United States Patent and Trademark Office

APPLICATION NO.	F	LING DATE	FIRST NAMED INVENTOR	ATTORNEY DOCKET NO.	CONFIRMATION NO.	
10/723,660	10/723,660 11/26/2003		Rick James Morse	D0932-00428 [VS-8855]	8809	
8933	7590	06/02/2006		EXAMINER		
DUANE N IP DEPART	•	LLP	HORTON, YVONNE MICHELE			
30 SOUTH		EET	ART UNIT	PAPER NUMBER		
PHILADEL	PHIA, PA	19103-4196	3635

DETAILED ACTION

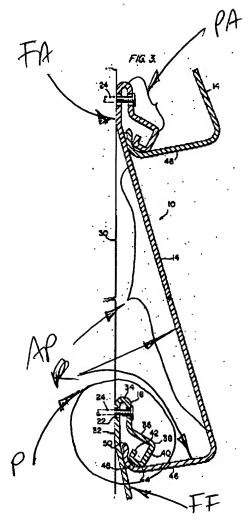
Claims 1,4,6 and 27 stand and claim 28 is rejected under 35 U.S.C. 102(b) as being anticipated by US Patent #4,334,396 to HAGOPIAN. Regarding claims 1 and 27, HAGOPIAN discloses the use of a siding panel (10) having a front (14) and rear face

(R), wherein the rear face (R) has a first area (FA) at a top end that is flush with the vertical wall (30), and an angled portion (AP) that overlaps at least a portion (P) of a second siding panel (10) see below. The rear face (R) includes a portion (48) proximate a bottom end thereof that rests upon a front face (FF,14) of the second siding panel (10). In reference to claim 4, the first area (FA) is reinforced via portions (16, 32, 36, 40). Regarding claim 6, the reinforced area (16, 32, 36, 40) includes a planar face (32) that is flush with the vertical wall (30). With further reference to claim 27, the first portion that is obliquely angled is portion (AP), and the second portion that is flush is portion (FA). Regarding claim 28, the second portion (FA) includes a protruding area (PA), see below.

Claims 17-19 and 21 stand rejected under 35 U.S.C. 102(b) as being anticipated by US Patent #4,334,396 to HAGOPIAN. The structure of HAGOPIAN inherently discloses the method of installing the siding panel, as detailed above, including the steps of providing the panel and attaching a first panel and a second panel to a structure (30) such that a rear face (R) of the siding (10) includes a portion (48) proximate a bottom end thereof that rests upon a front face (FF,14) of the second siding panel (10), see figure 3. Regarding claim 18, the first area (FA) is reinforced via portions (16, 32, 36, 40). In reference to claim 19, the attaching step involves driving a blind nail (24), positioned as at the bottom of figure 3, through the reinforced area (RA) and the vertical wall (30). Regarding claim 21, the attaching step also includes driving a nail (24), as at the top of figure 3, through the first area (FA).
